AGENDA ITEM

Council Assessment Panel (CAP) on 14 August 2023

DEVELOPMENT NO.:	23008098
APPLICANT:	Evo Arc Adelaide
ADDRESS:	85-87 PROSPECT RD PROSPECT SA 5082
NATURE OF DEVELOPMENT:	Two Storey Mixed Use Building comprising 8 Ground Floor Retail Tenancies and a First Floor Indoor Recreation Facility, Advertising Displays, Solar Photovoltaic Panel System (Roof-Mounted), car parking, landscaping, rainwater tank and roof-mounted plant infrastructure.
ZONING INFORMATION:	<p>Zones:</p> <ul style="list-style-type: none"> • Urban Corridor (Main Street) <p>Overlays:</p> <ul style="list-style-type: none"> • Regulated and Significant Tree • Traffic Generating Development • Urban Transport Routes • Airport Building Heights (Regulated) • Advertising Near Signalised Intersections • Affordable Housing • Design • Heritage Adjacency • Hazards (Flooding - General) • Noise and Air Emissions • Prescribed Wells Area <p>Technical Numeric Variations (TNVs):</p> <ul style="list-style-type: none"> • Maximum Building Height is 15m • Minimum Building Height is 2 levels • Maximum Building Height is 4 levels • Minimum Primary Street Setback is 0m • Interface Height (Development should be constructed within a

Figure 4: Heavy Vehicle Exit

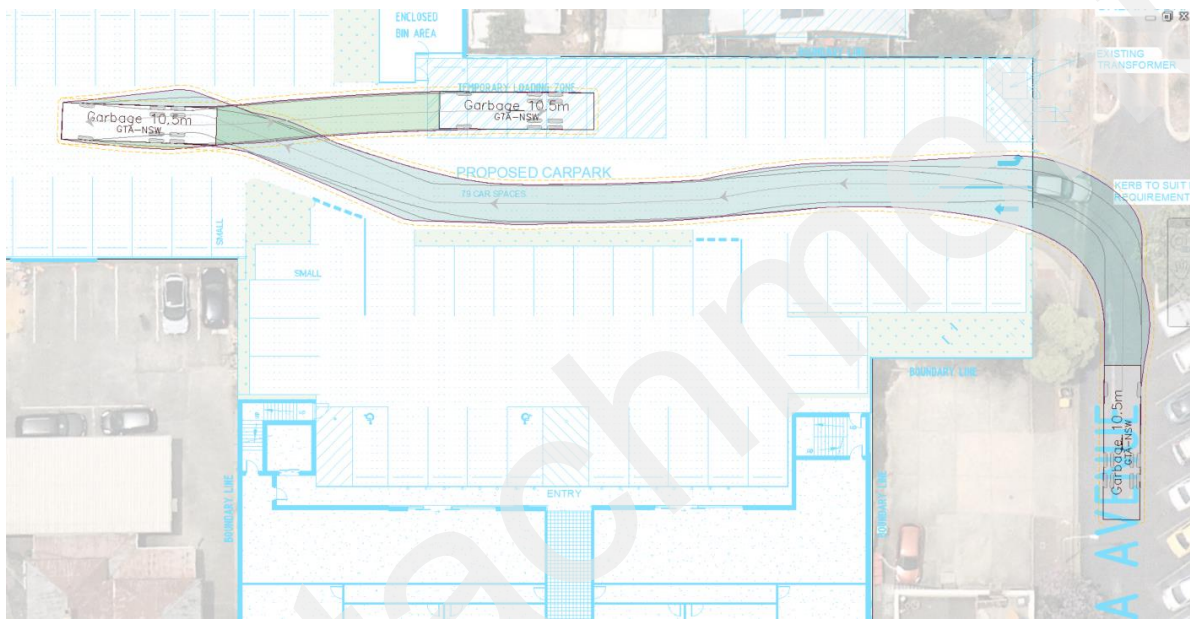
- Has tracking for an 8m or 9m delivery vehicle been checked to ascertain if ancillary loading can be provided closer to the building/ elevator/ tenancies?
- Recommend that any approval is subject to a Section 221 application being resolved for the canopy and a Construction Traffic Management Plan being provided which outlines construction staging, methodology, and traffic and access requirements - including deliveries and crane/ heavy machinery access and impacts noting that the build would need to be staged from the rear carpark.

- Car parking layout and loading Zone has been revised. Updated turn path diagrams provided. The turn paths are for the largest expected vehicle based on a 10.5m rigid truck.
